# PEERLESS FARMS PRELIMINARY PLAN 16975 FALCON HIGHWAY, PEYTON, CO

**COVER SHEET**  
**SHEET 1 OF 3**

PRELIMINARY PLAN  
SHEET 2 OF 3

# V2\_Preliminary Plan Drawings.pdf Markup Summary

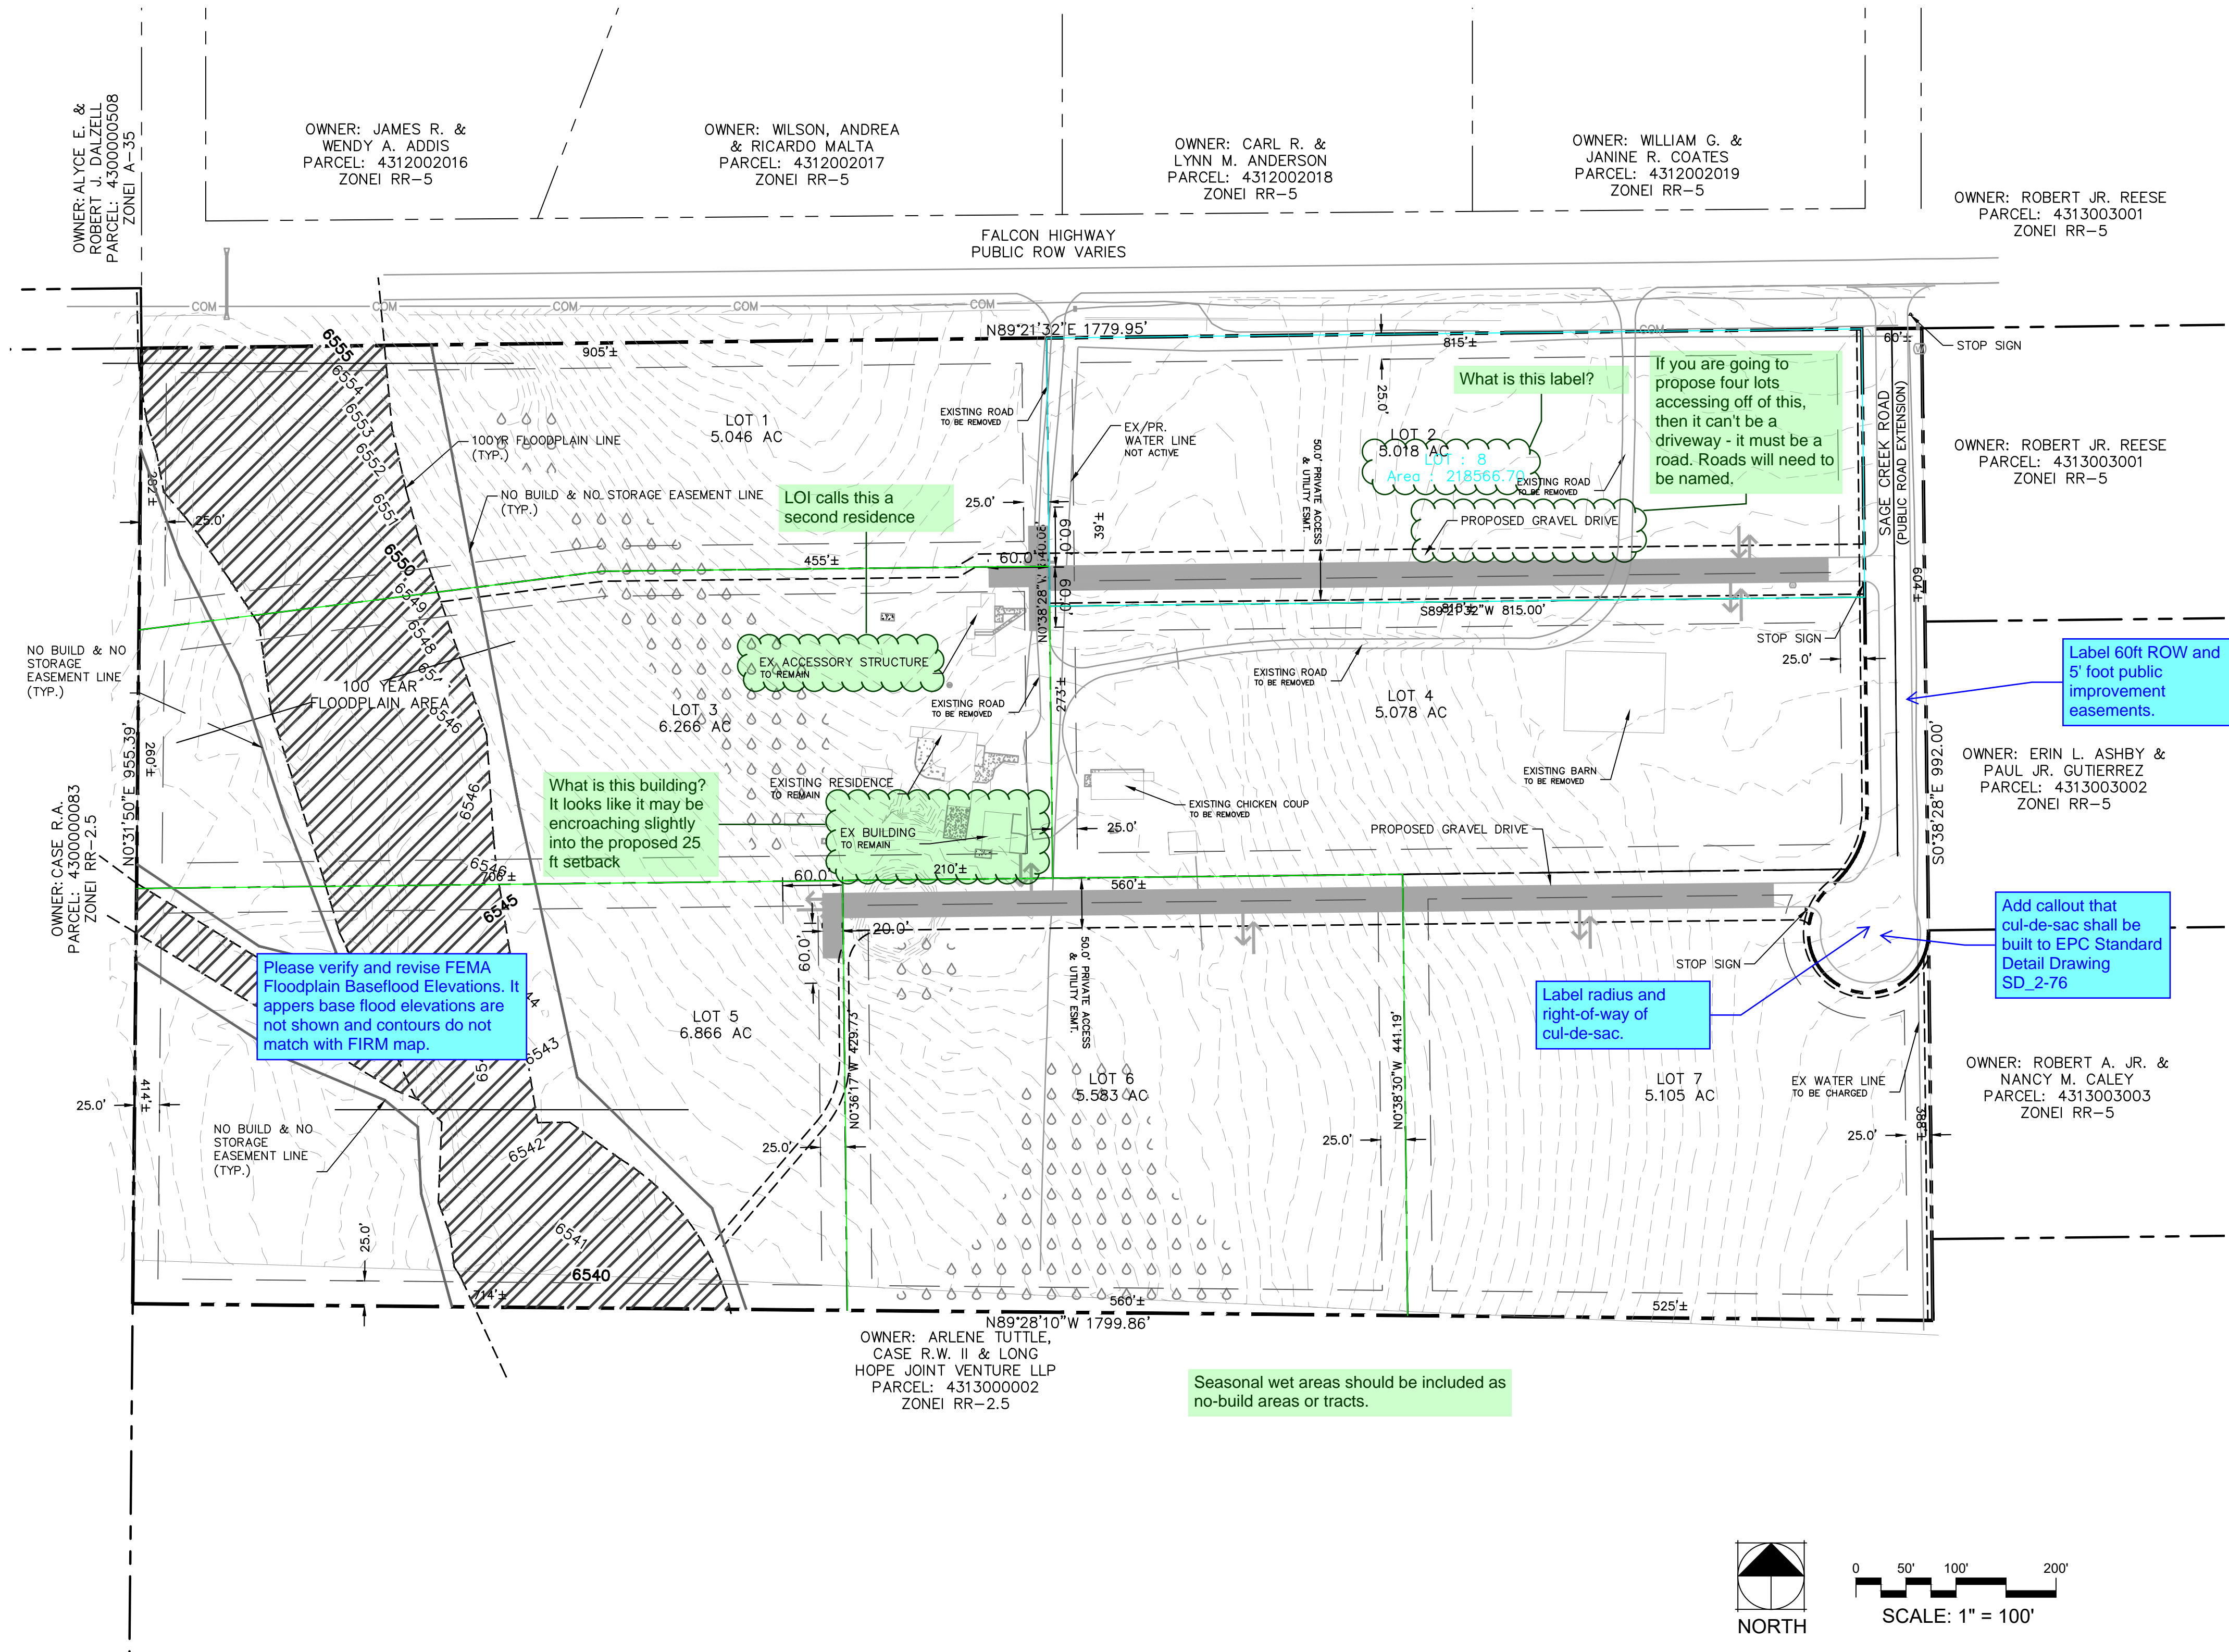
Add callout that cul-de-sac shall be built to EPC Standard Detail Drawing SD\_2-76

Label radius and right-of-way of cul-de-sac.

Label 60ft ROW and 5' foot public improvement easements.

LOI calls this a second residence

What is this building? It looks like it may be encroaching slightly into the proposed 25 ft setback

Seasonal wet areas should be included as no-build  
 areas or tracts.

What is this label?

If you are going to propose four lots accessing off of this, then it can't be a driveway - it must be a road. Roads will need to be named.

Please verify and revise FEMA Floodplain Baseflood Elevations. It appears base flood elevations are not shown and contours do not match with FIRM map.
